**TECHNICAL BULLETIN**

FAM-A-0035-C

## **Notice of Addition of Standards Display**

MELSEC iQ-F series and MELSEC-F series

FX5 communication board

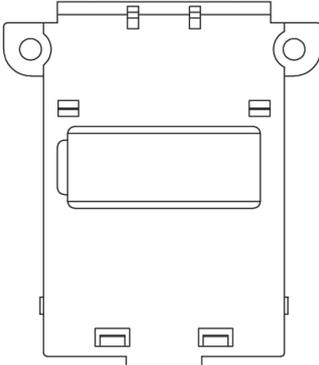
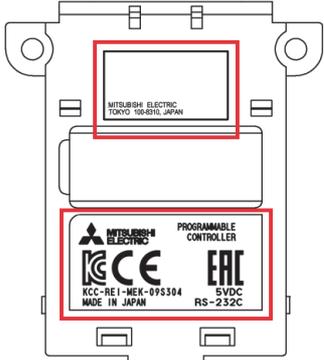
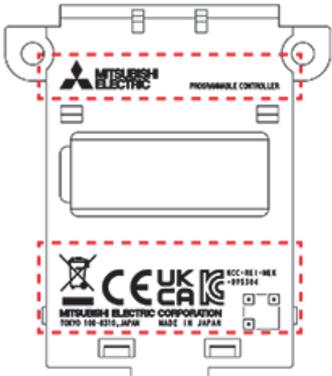
| Target product   |                     |  | Details on the changes  |   |
|--|---------------------|--|---|---|
| Example: FX5-485-BD<br> | Communication board | <ul style="list-style-type: none"> <li>FX5-232-BD</li> <li>FX5-485-BD</li> <li>FX5-422-BD-GOT</li> </ul> | <ul style="list-style-type: none"> <li>September 2021 and earlier</li> </ul> No standards display<br> | <ul style="list-style-type: none"> <li>October 2021 and after</li> </ul> Addition of standards display (a sticker on a product)<br><br><br><ul style="list-style-type: none"> <li>December 2022 and after</li> </ul> Change of display method (laser printing on a product)<br> |

Expansion board for the FX3U and FX3UC

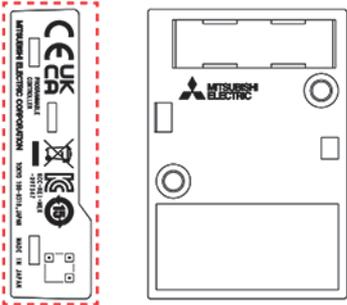
| Target product  |                 |  | Details on the changes  |   |
|---|-----------------|--|---|---|
| <p>Example: FX3U-232-BD</p>  | Expansion board | <ul style="list-style-type: none"> <li>• FX3U-232-BD</li> <li>• FX3U-422-BD</li> <li>• FX3U-485-BD</li> <li>• FX3U-8AV-BD</li> <li>• FX3U-USB-BD</li> <li>• FX3U-CNV-BD</li> </ul> | <ul style="list-style-type: none"> <li>• September 2021 and earlier</li> </ul> <p>No standards display</p>  | <ul style="list-style-type: none"> <li>• October 2021 and after</li> </ul> <p>Addition of standards display (a sticker on a product)</p> <br><ul style="list-style-type: none"> <li>• December 2022 and after</li> </ul> <p>Change of display method (laser printing on a product)</p>  |
